GS# 210-068 NEW ADMINISTRATION BUILDING PHASE II

Mississippi Delta Community College

Addendum No. 2

1 Site Plan - Electrical
1" = 20'-0"

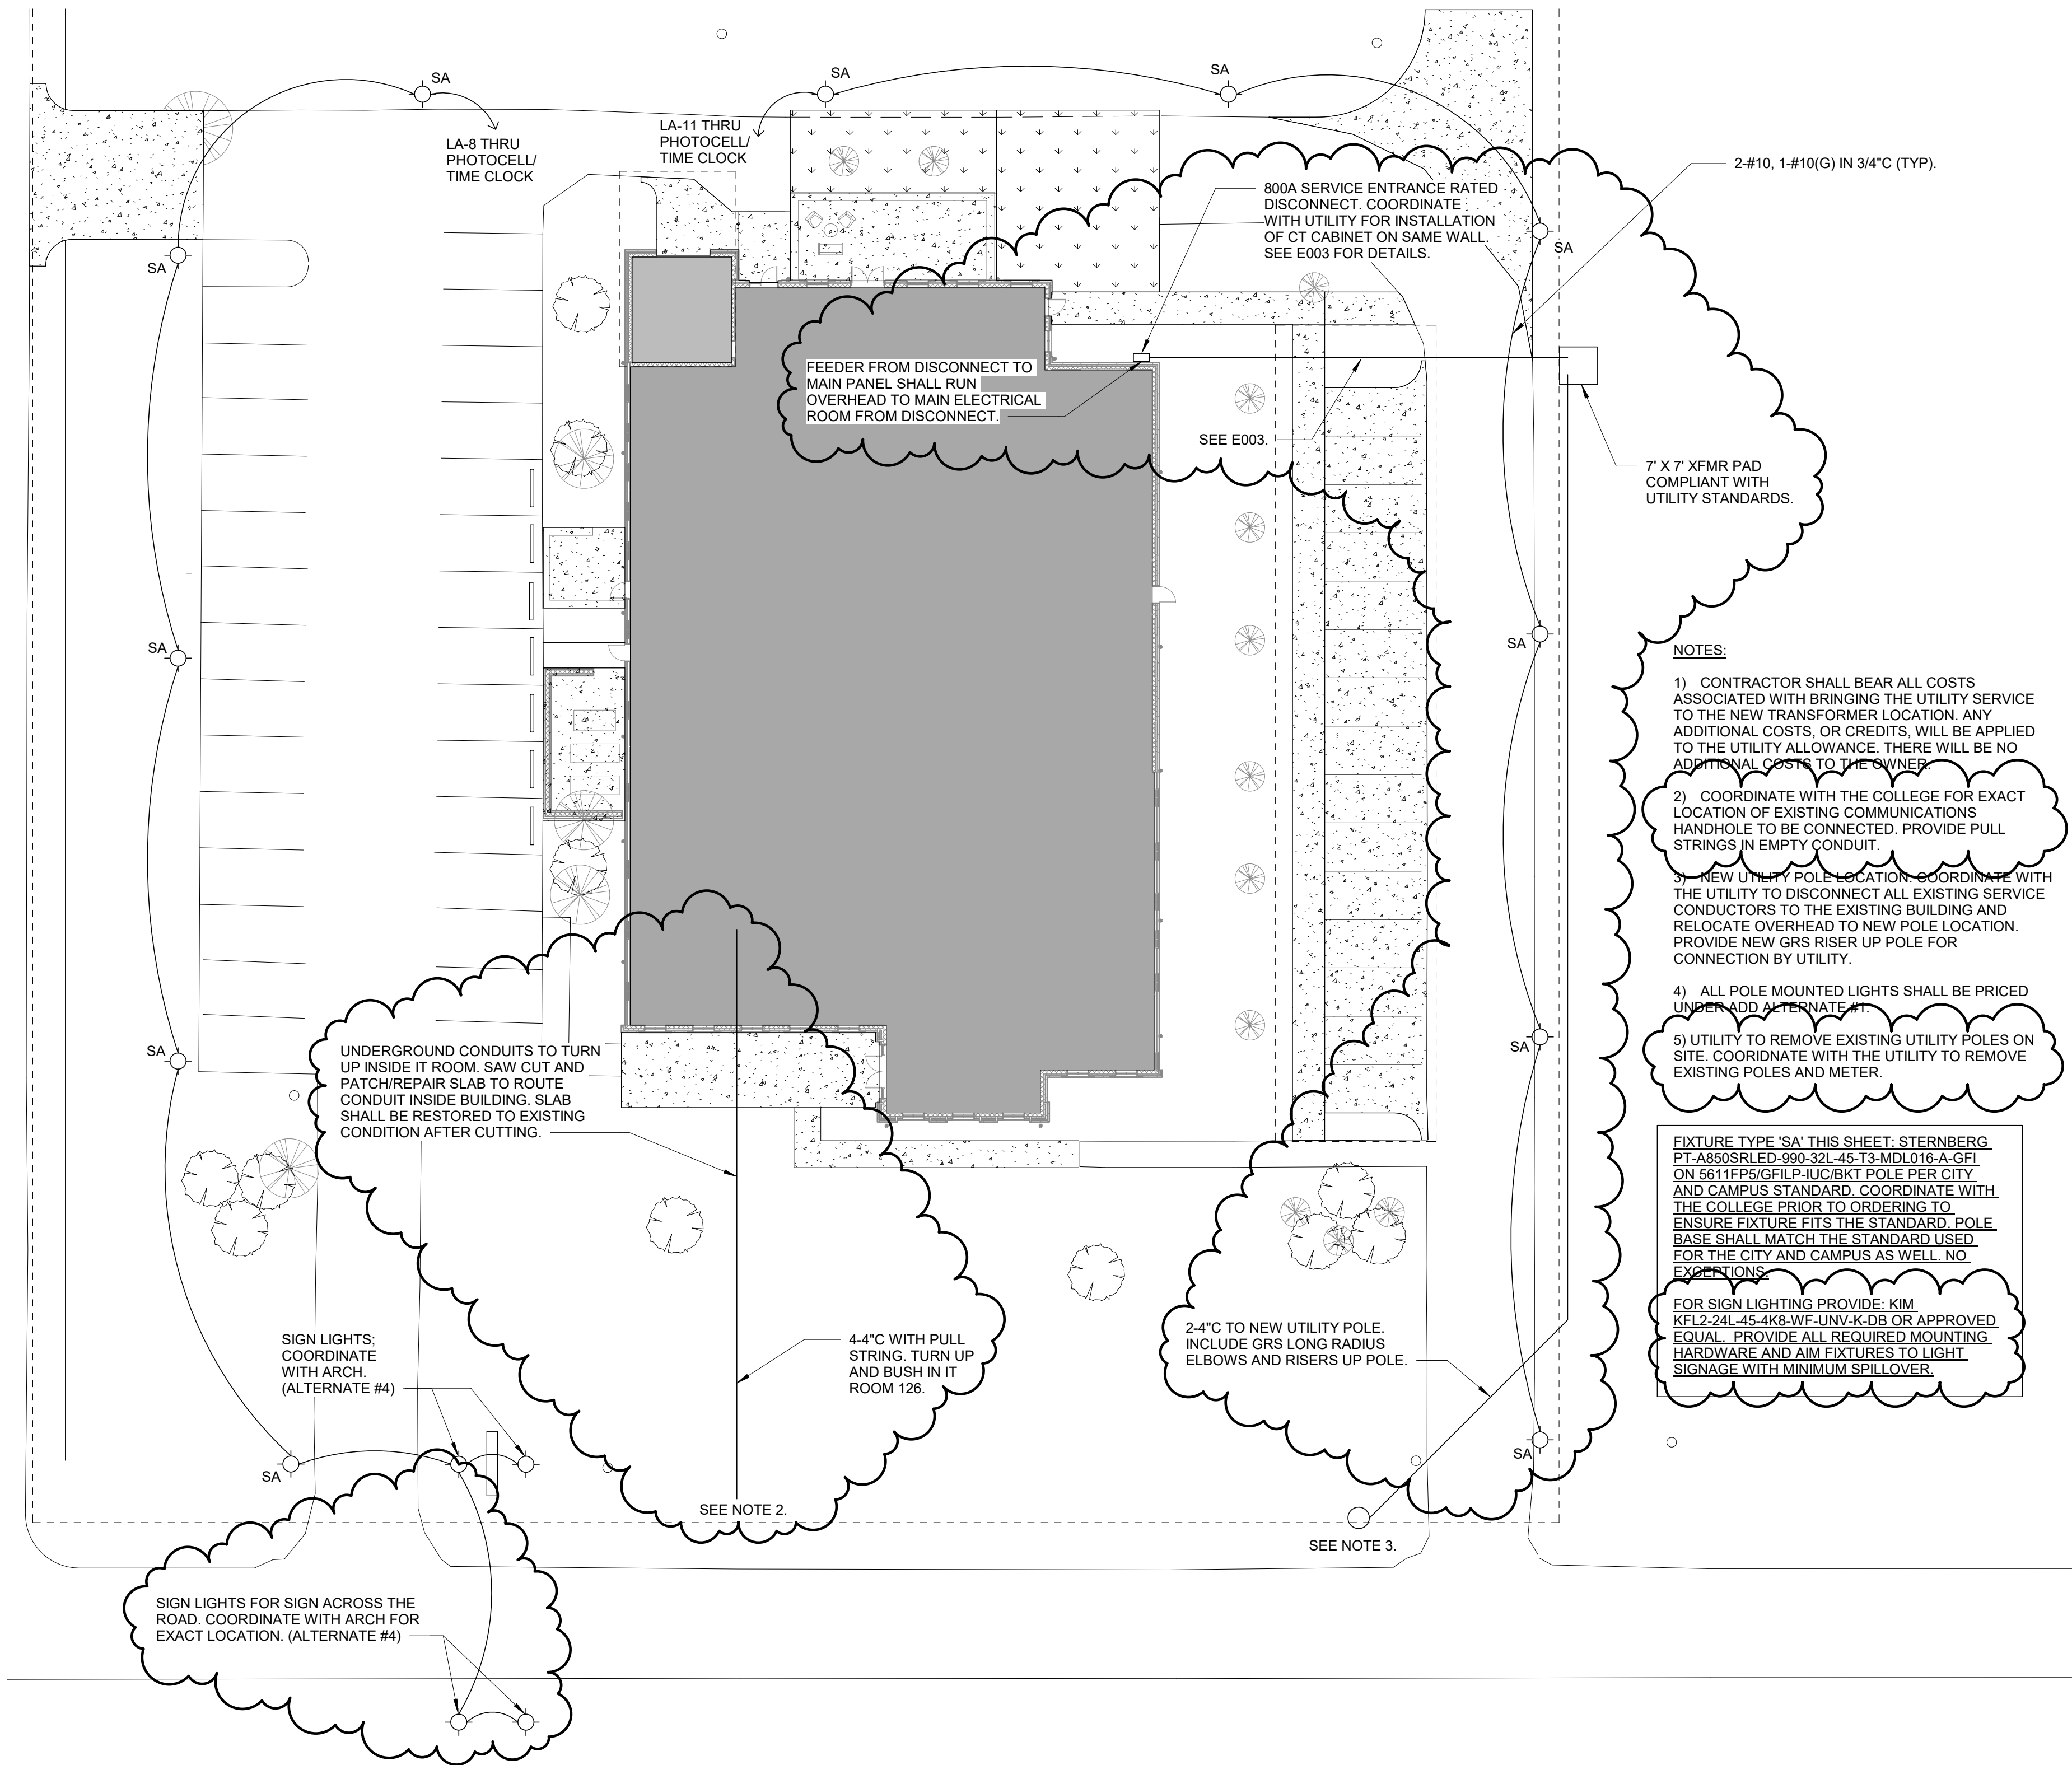
- a. Sheet A223
 - i. 7/A223 – REVISE 'FIN WD CABINETS W/ ADJUSTABLE SHELF' TO 'PLAM CABINETS W/ ADJUSTABLE SHELF'.
- b. Sheet A610 Finish Schedule – where discrepancies exist between Finish Schedule and Floor Finish Plan for flooring types, the Floor Finish Plan shall govern. See A140 Finish Floor Plan.
- c. Sheet E001: Revised minimum conduit size to ½"
- d. Sheet E002: Added pole base detail.
- e. Sheet E100: Added Mezzanine plan and revised switching in mechanical access to manual from occupancy sensor.
- f. Sheet E300: Added duct smoke detectors for IHP-2-1. Clarified via note requirements for voice alarm, testing, and CCTV/Access Control scope.
- g. Sheet ES100: Added sign lighting across the street, a sign lighting specification, and altered incoming utility route to include pad mounted transformer. Clarified conduit entrance for communications.
